APPLICATION TO THE PLANNING BOARD

BOUNDARY & TOPOGRAPHIC SURVEY OF BLOCK 103, LOT 1 50 RUMSON ROAD

**Re: TagCap Atlantic 50 Rumson, LLC
Minor Subdivision Plan
50 Rumson Road (CR 520); Block 103 Lot 1, R-2 Zone
Completeness Review, Engineering Review and Fee Determination**

RE: RMSB967 - TAGCAP Atlantic 50 Rumson, LLC
Block 103 – Lot 1
Borough of Rumson

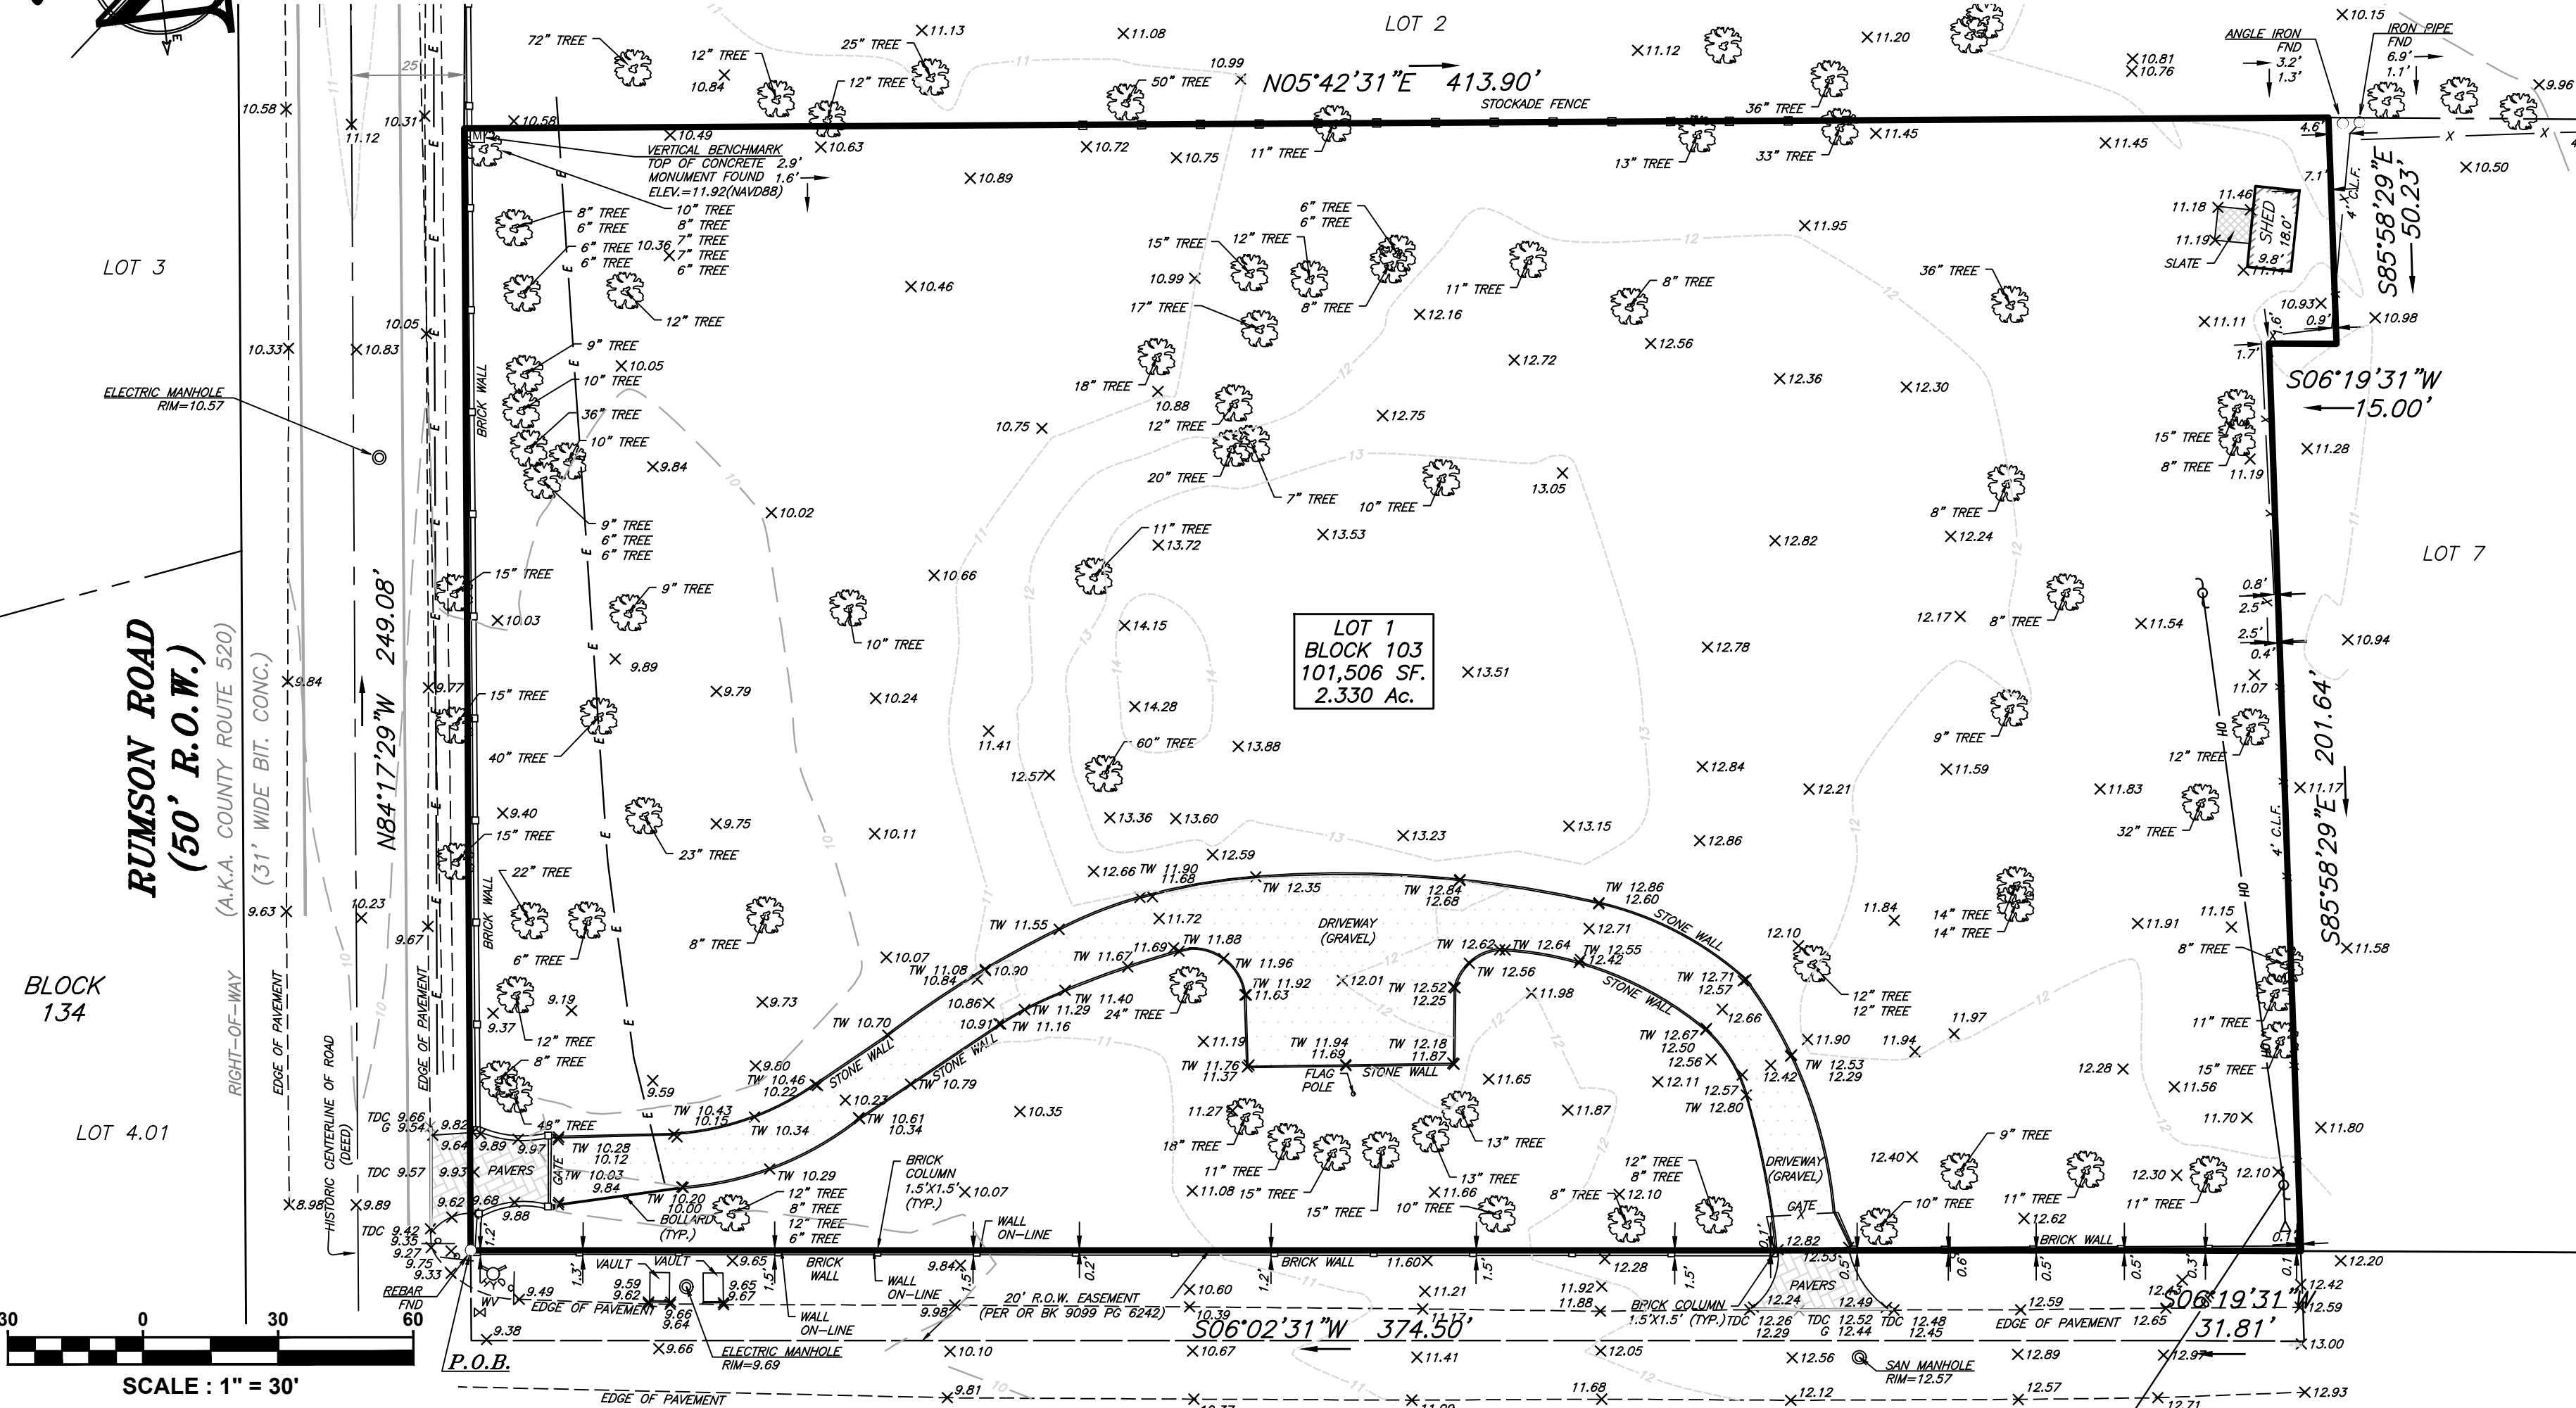
- 6.1 The survey and landscaping plans do not adequately demonstrate compliance with Ordinance §16-1.4 – Prohibited Activities. The survey shall be updated to identify tree species. The plans shall identify compliance with the following subsections:
